# Access Compliance Report

## Public Rights-of-Way

Intersection ID: 11815	Main Street: N_POPLAR_ST	Cross Street: W_7TH_ST	Location: N
ADA ID: 875E5015B919	Ramp Type: PerpDiag	Initial Pass/Fail: Fail	Overall Compliance: No
			Severity Score: 13.75

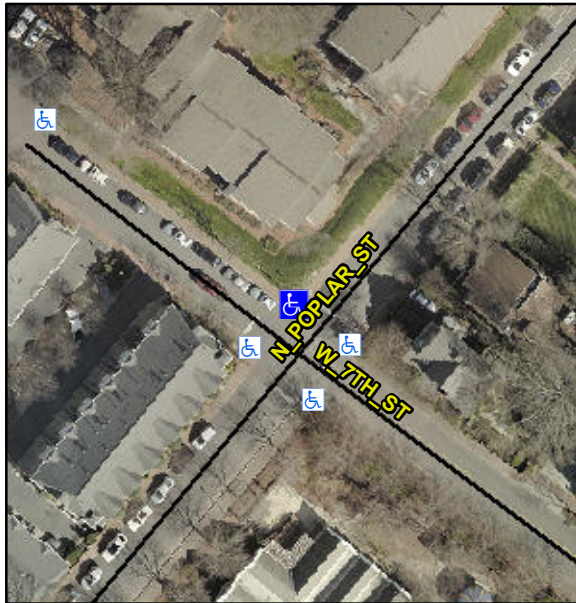
**R304.2.2, R304.5.3**

Compliance	Description	Data	Compliance	Description	Data
N/A	Ramp Length (in)	52.0	No	Ramp Slope (%)	10.2
Yes	Ramp Width (in)	50.0	No	Ramp XSlope (%)	4.1
N/A	Flare Type LT	N/A	N/A	Flare Type RT	N/A
N/A	Flare Slope LT (%)	N/A	N/A	Flare Slope RT (%)	N/A
N/A	Flare Traversable LT?	N/A	N/A	Flare Traversable RT?	N/A
N/A	Landing Length (in)	N/A	N/A	DWS Provided?	N/A
N/A	Landing Width (in)	N/A	N/A	DWS Contrast?	N/A
N/A	Landing Slope (%)	N/A	N/A	DWS Length (in)	N/A
N/A	Landing X Slope (%)	N/A	N/A	DWS Full Width?	N/A
N/A	Landing Curb? (Y/N)	N/A	N/A	DWS Offset (in)	N/A
N/A	Shared Landing?	N/A			
N/A	Gutter Ponding?	N/A	N/A	Gutter Slope (%)	N/A
N/A	Gutter Lip Ht (in)	N/A	N/A	Gutter X Slope (%)	N/A
N/A	Painted X Walk1?	No	N/A	Painted X Walk2?	No
	X Walk 1 Direction	To SW		X Walk 2 Direction	To SE
N/A	X Walk 1 Width (in)	N/A	N/A	X Walk 2 Width (in)	N/A
	X Walk 1 Slope (%)	4.1		X Walk 2 Slope (%)	6.6
	X Walk 1 X Slope (%)	6.9		X Walk 2 X Slope (%)	0.0

**Remove & Replace Curb Ramp With Two New Directional Ramps or Equivalent.**
